TO: Mercedes-Benz Principals, General Managers, Sales Managers, Service Managers, Parts Managers	FROM: Anthony Washington, Department Manager, Regulations and Certifications
Re: Recall Campaign Launch Notification Model 907 (Sprinter) Model Year 2021 Replace Torsion Bar Linkage & Mounting Hardware	DATE: August, 2022

Campaign No. 2022080004, August, 2022

SUBJECT: **Model 907 Sprinter, Model Year 2021
Torsion Bar Linkage and Mounting Hardware**

D32.35-A004-79

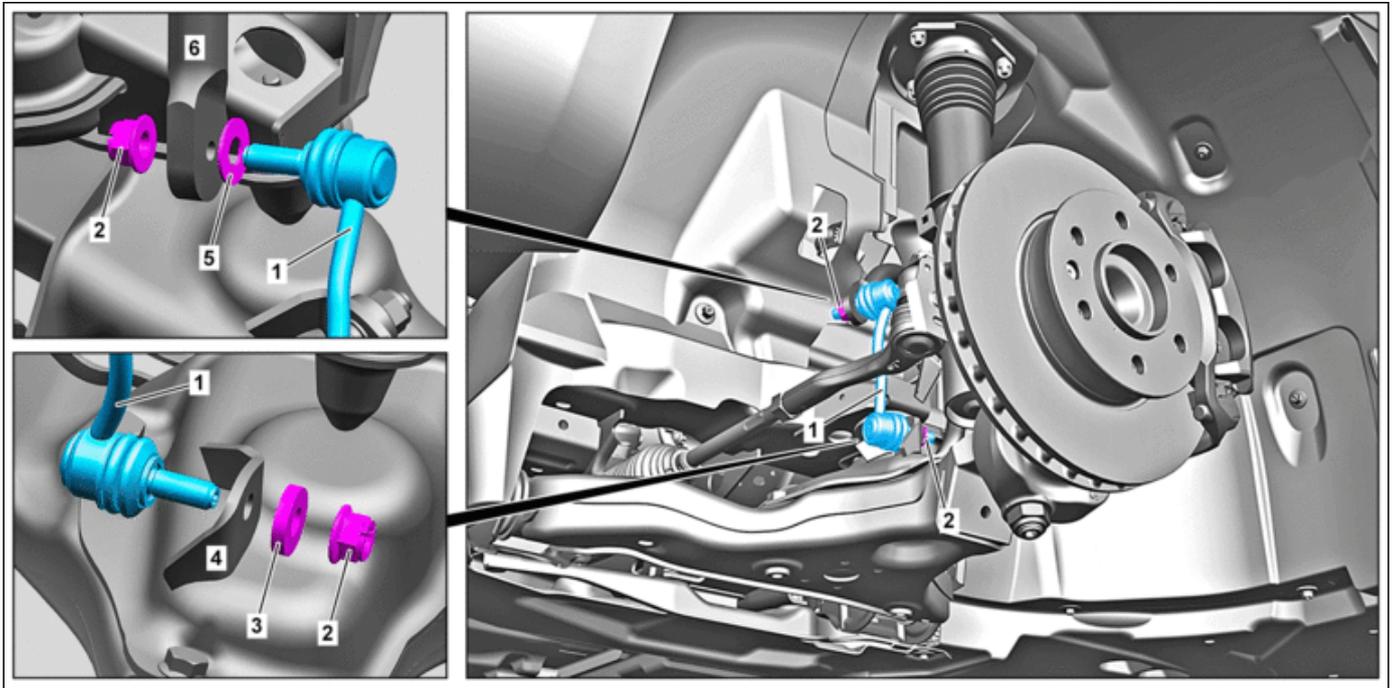
Mercedes-Benz AG (MBAG), the manufacturer of Mercedes-Benz Sprinter vans, has determined that the torsion bar on certain Sprinter vehicles was not assembled to the torsion bar linkage by the component supplier in accordance with design specifications. The shim on the torsion bar was incorrectly installed between the nut and the torsion bar, rather than between the ball stud and the torsion bar. Due to the incorrect assembly, the torsion bar may not meet operational strength requirements. Settling effects may occur between the journal flange and the torsion bar. These effects might reduce the bolt preload at the connection, which could increase fatigue on the journal and lead to a fatigue fracture of the journal, which could increase the risk of a crash.

◀	Check		
1	Check, whether the vehicle is affected by the measure.	Affected vehicles: Replace torsion bar linkage (code: VS3VADREH, acc. no.: 32 920 17) Model 907 ### ## as of 055804 up to 374997 with code CB4 (Stabilisation, stage III)	SM32.35-D-0023-01AAA
✕	Remove		
2 AR	Remove both front wheels.		AR40.10-D-1100TS
3	Remove nuts (2) from torsion bar linkages (1) on right and left side of vehicle.	If the threaded pin on the ball head turns too, ↓ counterhold the threaded pin.	
4	Remove torsion bar linkages (1).	i Remove shims (3, 5) too. The shim (5) may be attached to the wrong side of the torsion bar linkage (1). Replace torsion bar linkages (1).	
◀	Check		
5	Check shims (3, 5) for damage.	If shims (3, 5) are damaged, ↓ replace shims (3, 5).	
✕	Install		
6	Install new torsion bar linkages (1).	⚠ Observe installation position of torsion bar linkages (1). The torsion bar linkage (1) only have sufficient clearance when in the correct installation position. i Position shim (3) between lower nut (2) and stop plate holder (4), as shown. Position shim (5) between threaded pin of torsion bar linkage (1) and stabilizer bar (6), as shown.
